**CITY OF PORTLAND, MAINE
DEVELOPMENT REVIEW APPLICATION
PLANNING DEPARTMENT PROCESSING FORM
DRC Copy**

161 - 161 Hope Ave , Portland, Maine

RE:
Lot 22
Presumpscot River Place

Lot 22 Site and Utility Plan

Drawing Name:
Space & Bulk Requirements
Project:
PRESUMPSCOT RIVER PLACE

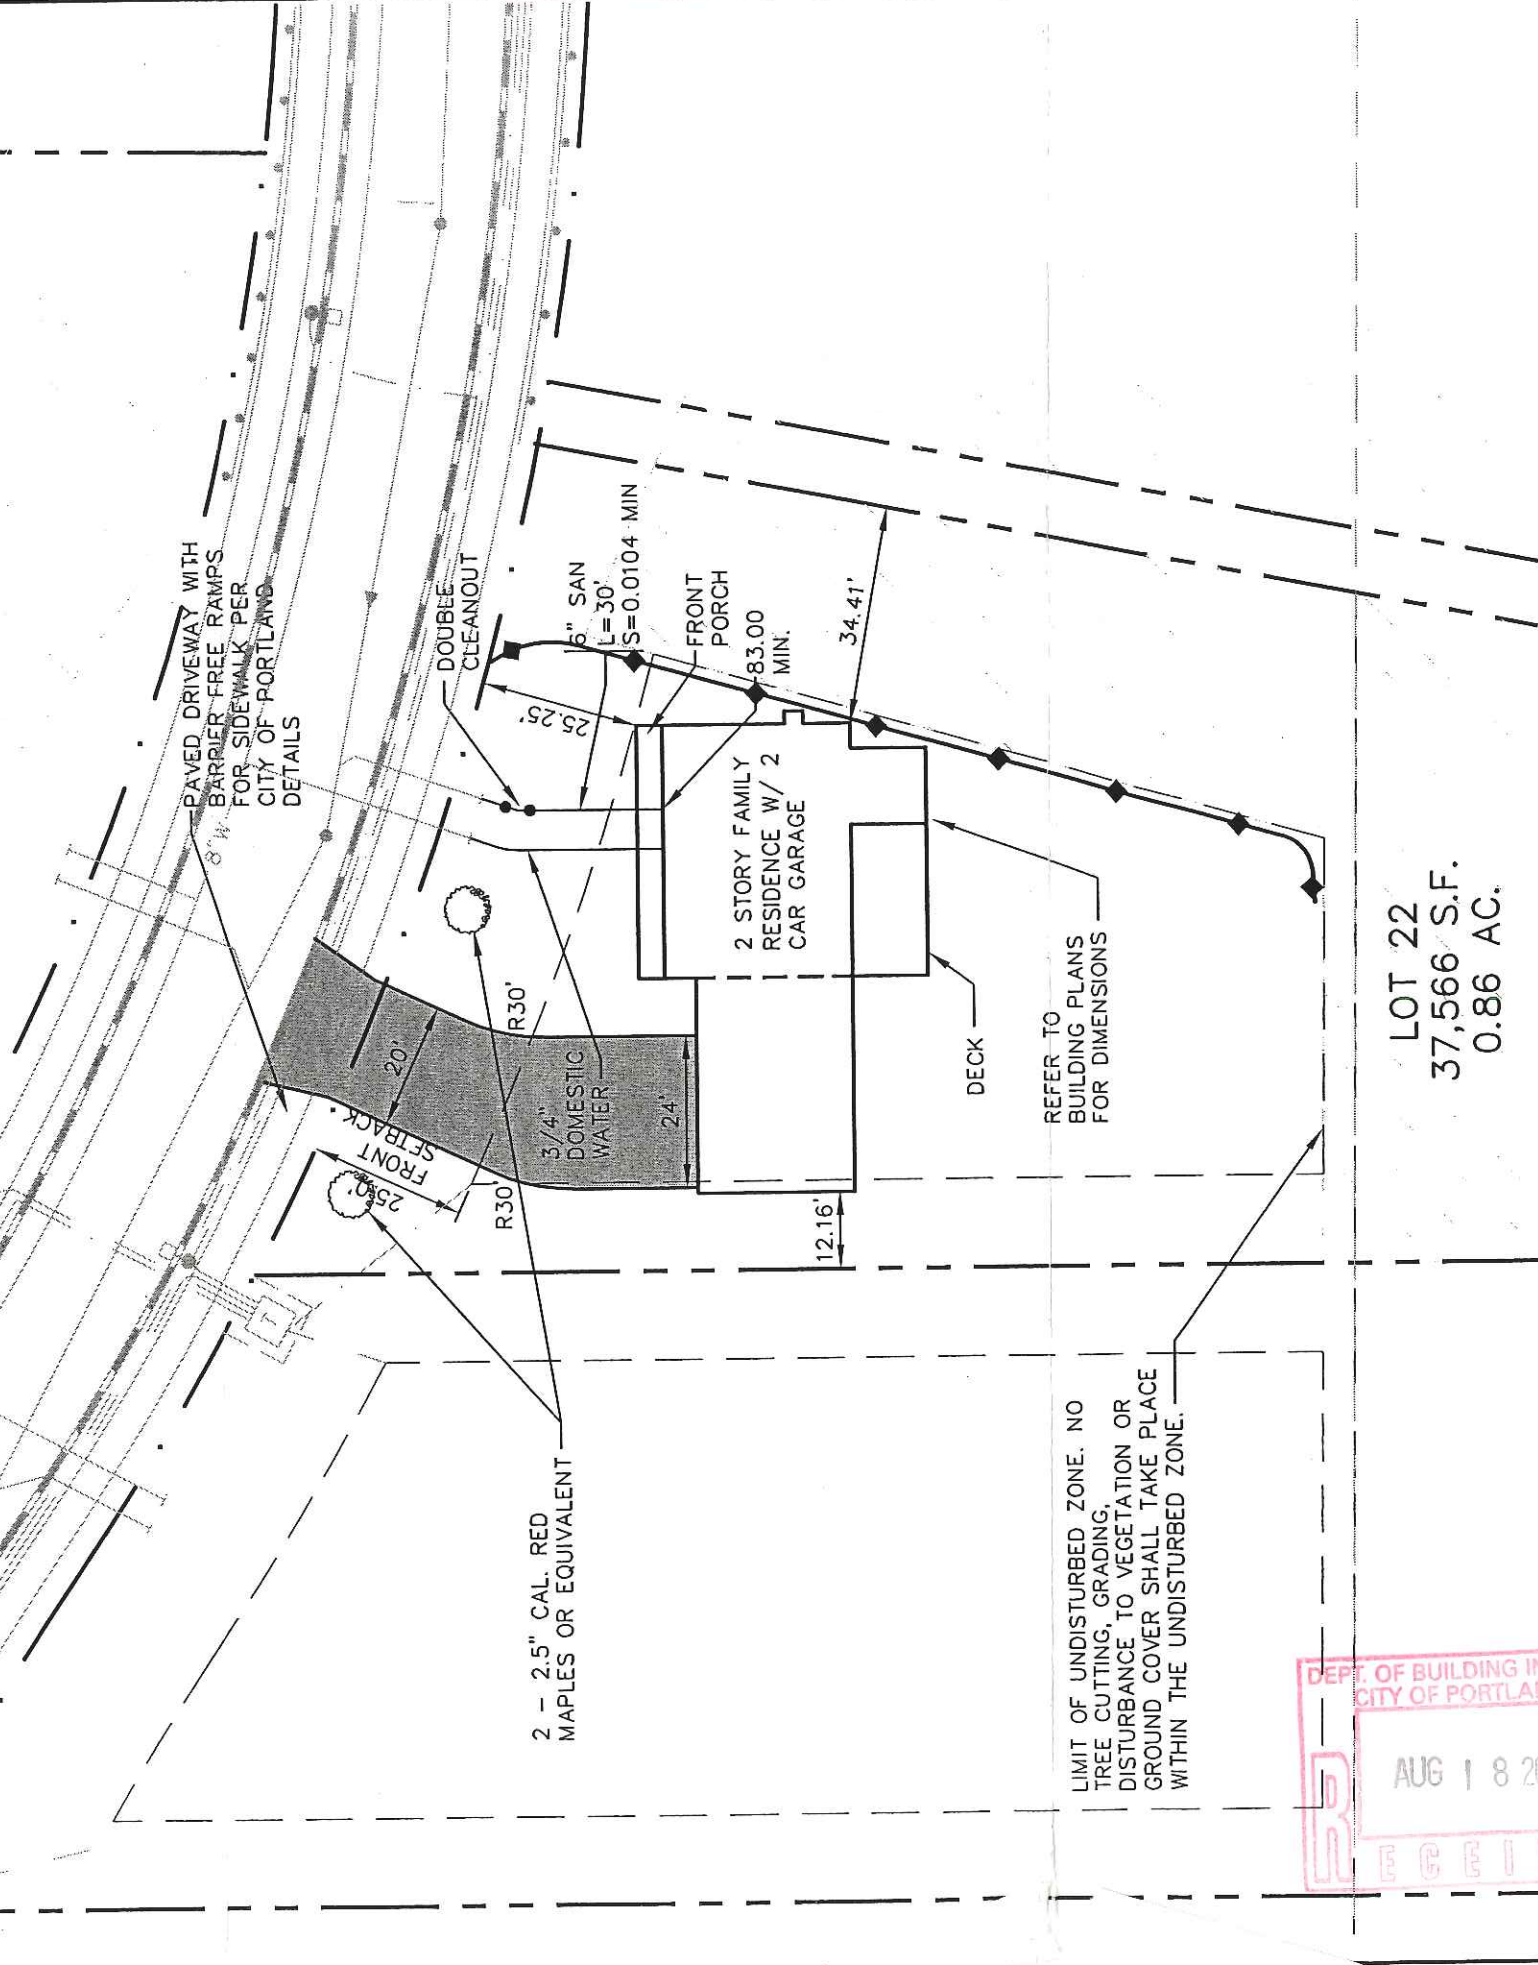
Your construction plans show a two story dwelling. The R-2 zone requires a fourteen (14) foot side yard setback for a two story dwelling. The required side yard setback may be reduced on one side yard to no more than twelve (12) feet, if for every foot reduced on that one side, it is added to the opposite required side yard. Your plans show one side yard to be eight and one quarter (8.25) feet from the side property line. This is less than the minimum required side yard setback. Please also note that a chimney may not extend more than two (2) feet into a required setback.

Drawing Name: Lot 22 Grading and Drainage Plan
Project: PRESUMPCOT RIVER PLACE

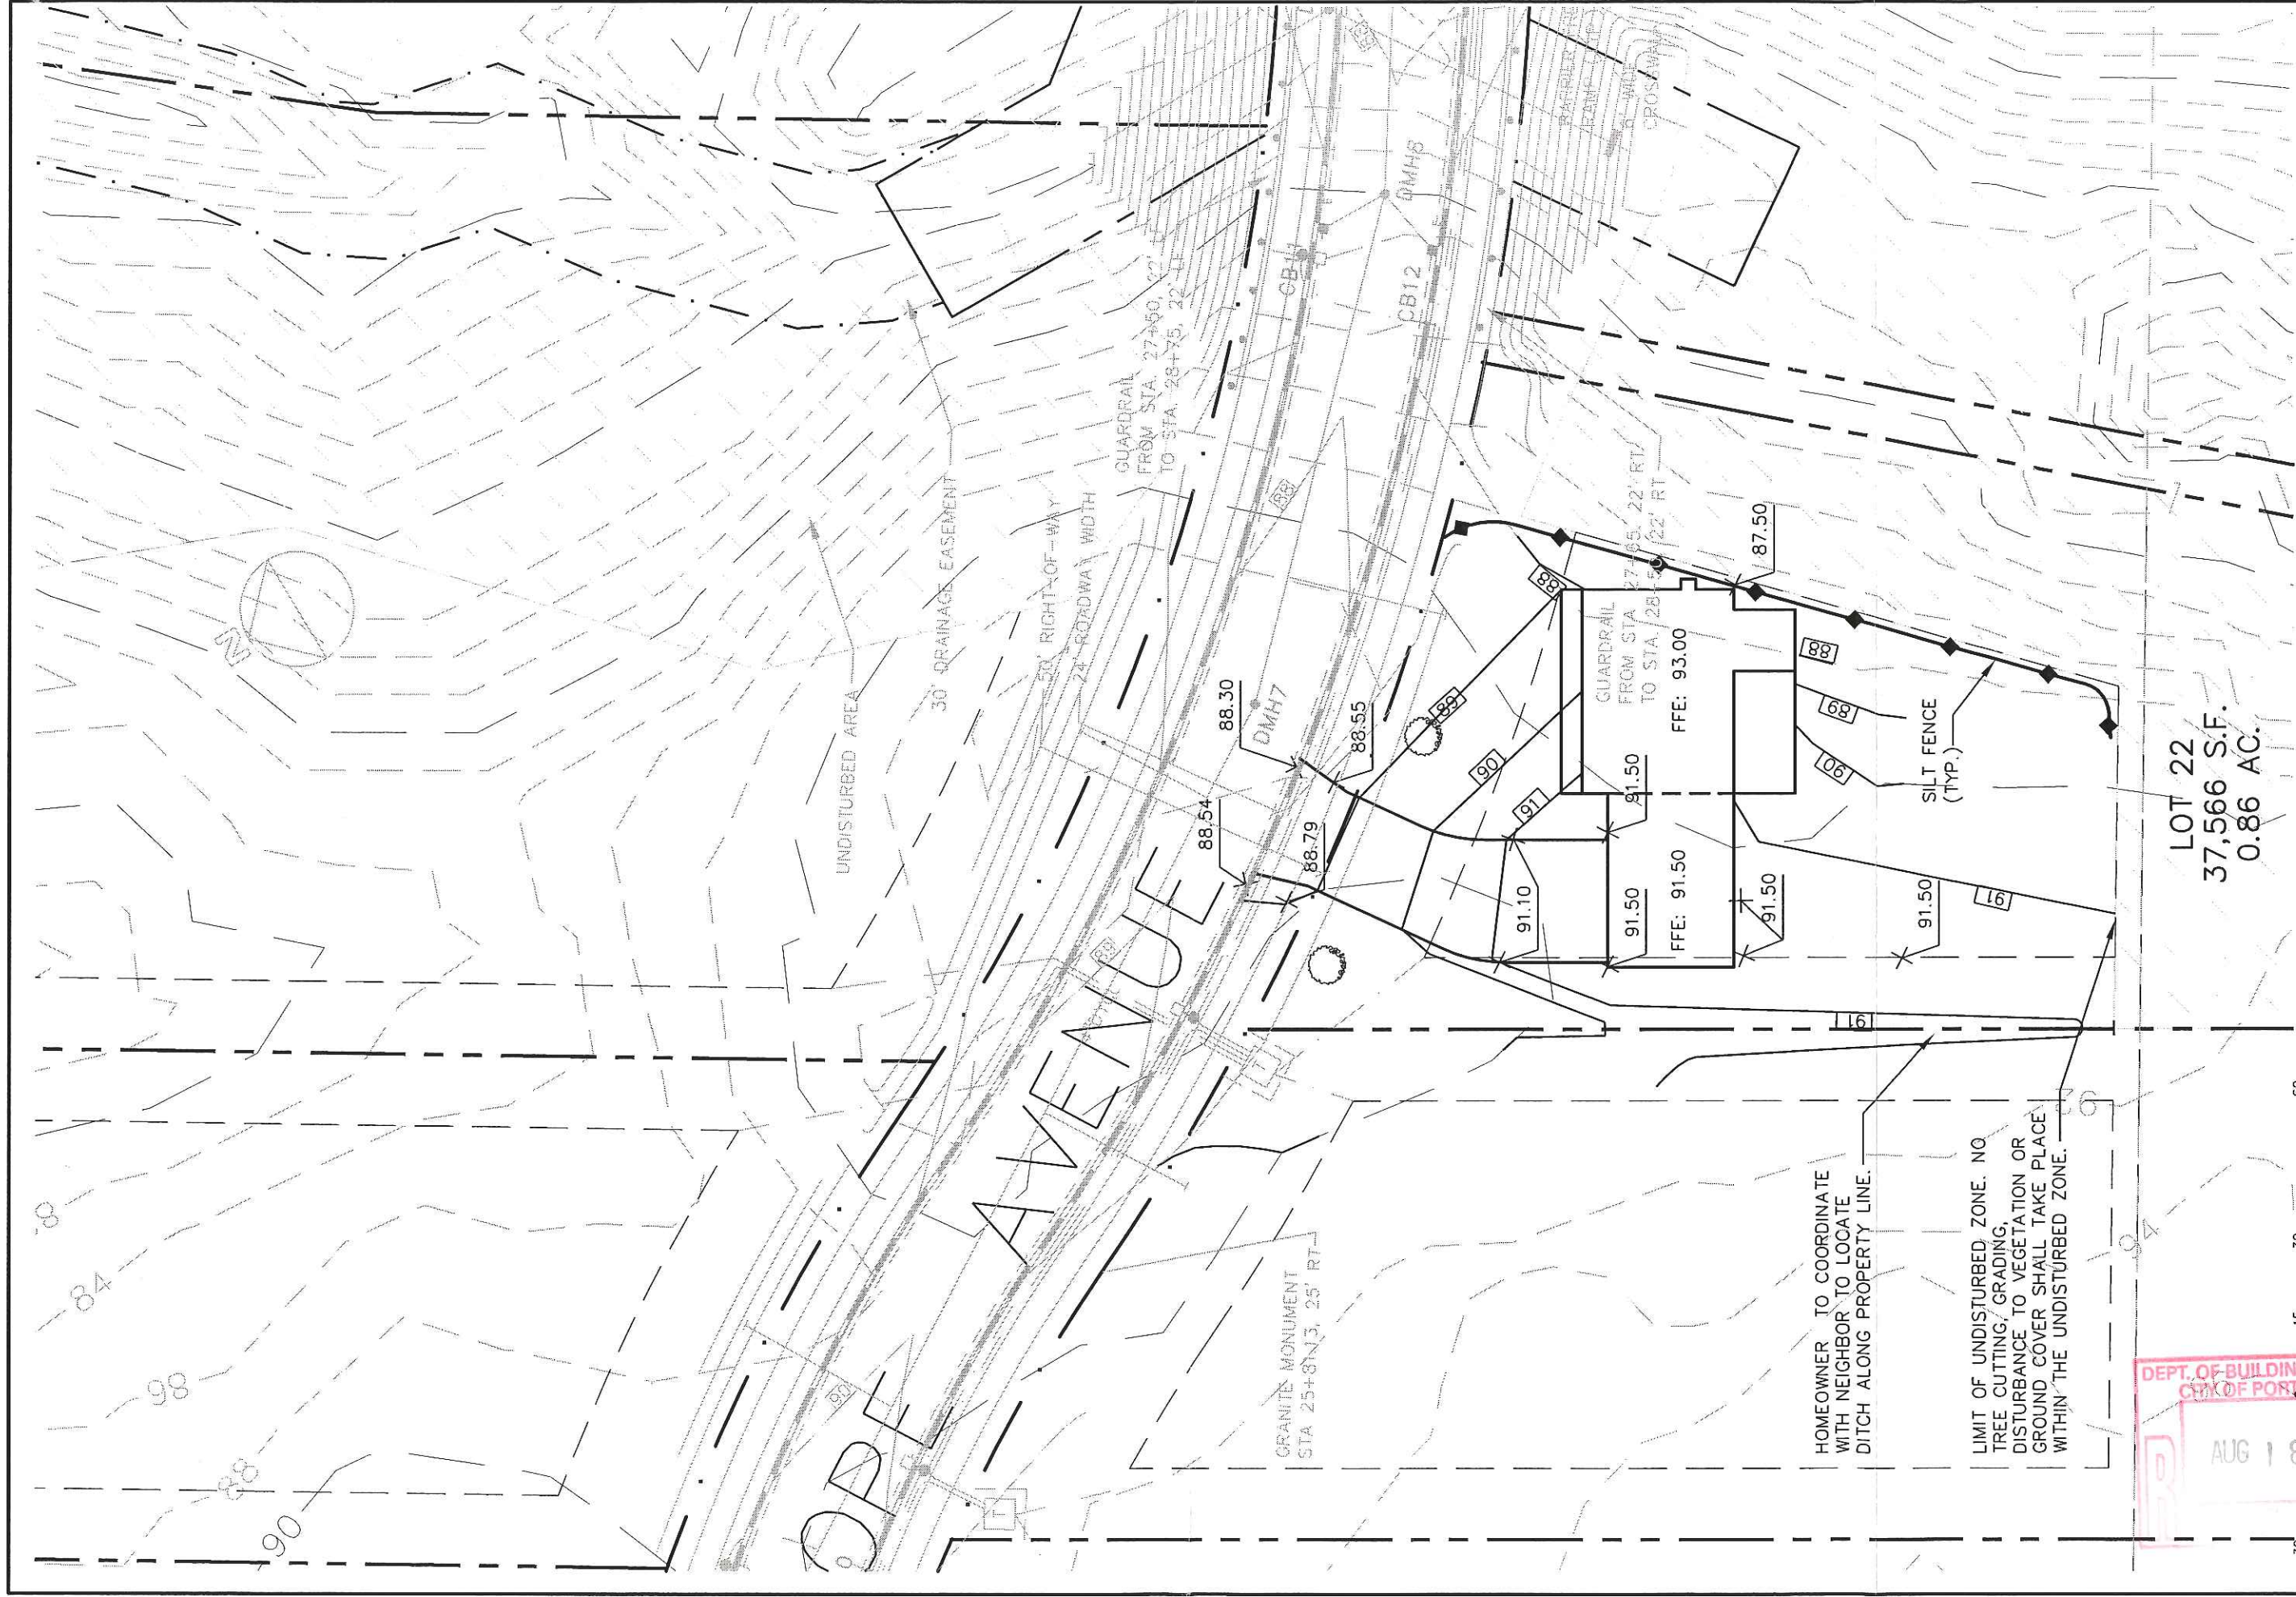
I don't really know, I guess it depends on what is in this undisturb zone.

If there are large Trees right at the edge of the zone, construction will damage the root systems of these trees. They would eventually die. Maybe the owner will want them removed due to being so close to the house.

If it's vegetation/scrub, then I guess we'll just see how it gets built out. At a minimum, the plans need to show and protect this area better (silt fence prior to construction?).

More attention is needed with regards to the 'Undisturb Zone'.

The proposed building sets within 3 feet of this zone.

The plan does not show any disturbance, however, the realities of construction tell me that this area will be disturbed, whether it's clearing, grubbing, erosion control installation, foundation pouring, etc. (Also, final grading on Contour 91 goes right to the very edge of the zone).

This undisturb zone is not clearly labelled and defined on your grading plan.

Please hatch/label the zone.

Please label the existing contours.

Please provide additional notes, narrative, or re-design to ensure compliance to the subdivision (undisturb zone).

Added *note* regarding survey of undisturbed zone.

LIMIT OF UNDISTURBED ZONE. NO
TREE CUTTING, GRADING, OR
DISTURBANCE TO VEGETATION OR
GROUND COVER SHALL TAKE PLACE
WITHIN THE UNDISTURBED ZONE.
